THE REGIONAL MUNICIPALITY OF YORK

ADDENDUM #4

BID # RFTC-652-22

FOR: Interior Renovation - 4th Floor (Block A, B, D and E) at the York Region Administrative Centre

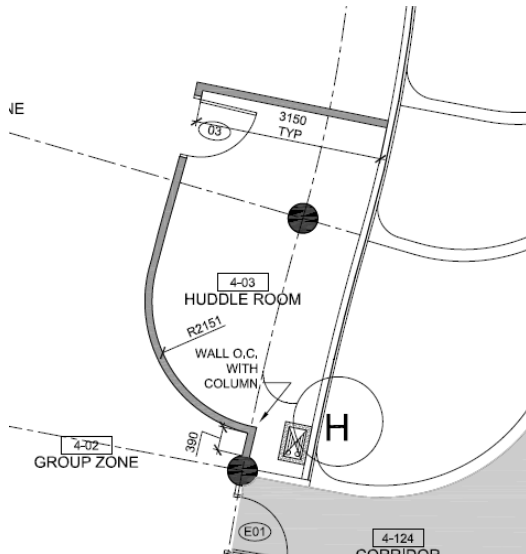
Room 4-03 Huddle room, should that partition read P-1 and not P-2 Altos Partition?

Yes, Huddle Room 4-03 should be P-1 Partition. Contractor to re-use and existing frame and door, from area of work. Site Super to select which door and frame to be reused with Architect and York Region Project Manager

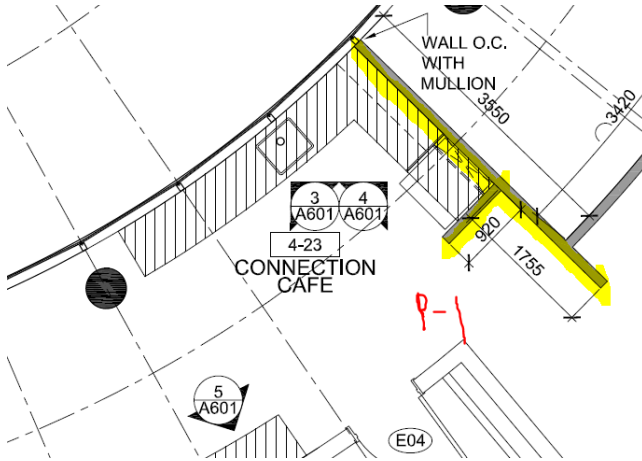
On the A200 Partition Drawing, should the wall behind the Connection Café 4-23 be P-1 Partition Type?

Yes

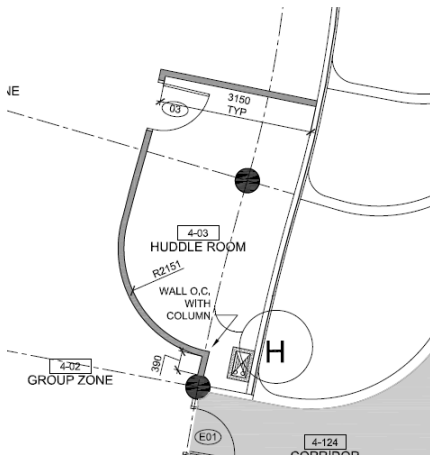
On the Partition Drawing, we do NOT see keynote 2 identified on the drawing? This is for the infill where the Altos Partitions meets the window.

The Contractor to carry 40 locations per detail 2/A600
